UNITED STATES
NUCLEAR REGULATORY COMMISSION
ADVISORY COMMITTEE ON REACTOR SAFEGUARDS
WASHINGTON, D. C. 20555

July 16, 1998

SUBJECT: PROPOSED REVISIONS TO 10 CFR 50.59 (CHANGES, TESTS AND EXPERIMENTS)

Figure 2. Acceptance Guidelines for Large Early Release Frequency (LERF), as given in RG 1.174.

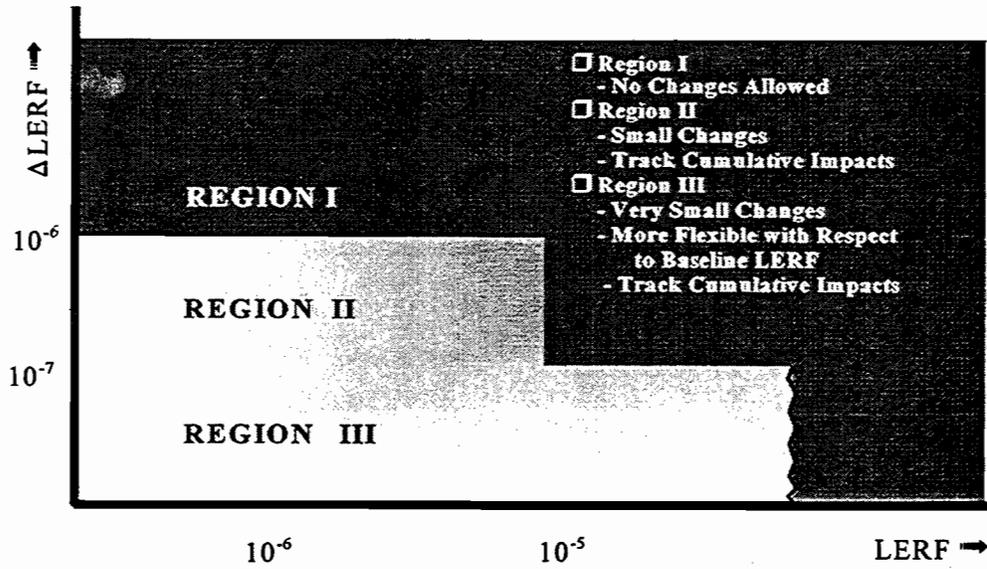
Yes. Regulatory Guide 1.174 requires that all increases in frequency must be reviewed by the staff, that is, Figure 2 does not have a region in which the change in frequency is so small that subjecting it to staff review would be a waste of everyone's resources.

"The analysis will be subject to increased technical review and management attention as indicated by the darkness of the shading of the figure."

Clearly, this "attention" is significant when either the goal is exceeded or when the change in frequency approaches the limit of 10^{-6} per reactor-year. An example of a region in which no review would be required is shown in Figure 4.
